Service Information

24 November 1989

UPPER PTO IDLER SHAFT - BORE RECLAIM SPECS 4640 and 4840 PST Tractors

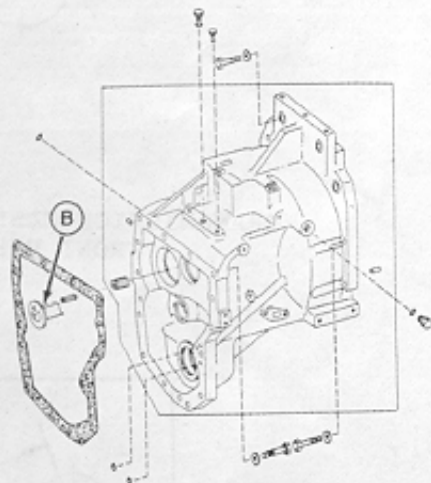
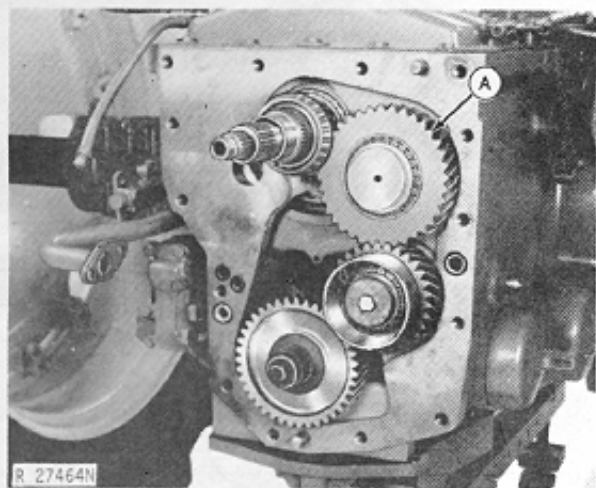
Depending on tolerances and PTO power usage, the upper PTO idler shaft (A) can rotate and wear into the clutch housing and/or transmission case. This shaft "creep", over an extended period of time, will cause improper gear contact in the PTO power train and eventual gear failure.

On 4640 (1000 - 20584) and 4840 (1000 - 11689), the R64249 Idler Shaft will sub to R72051 Shaft, R72052 Deflector, and 34H348 Spring Pin. The deflector (B) was installed on 4840 PST Tractors as a running change. Its purpose is to catch and route oil to lube the PTO idler gears and shafts. Tractors 4640 (1000 - 20584) and 4840 (1000 - 11689) are not equipped with this feature. They did, however, utilize a retainer on the idler shaft to

Dealers attempting to sleeve the respective bores need original bore dimensions and reference points. Reference Page 2 for original dimensions and SIB R85-50-16 for general machining guidelines.

distribute oil. Tractors with an upper PTO idler shaft failure are instructed to order the new shaft and deflector for installation. It is important to note that the PTO idler shafts can normally be a slip fit of about 0.03 - 0.05 mm (0.001 - 0.002 in.) in the clutch housing and transmission case.
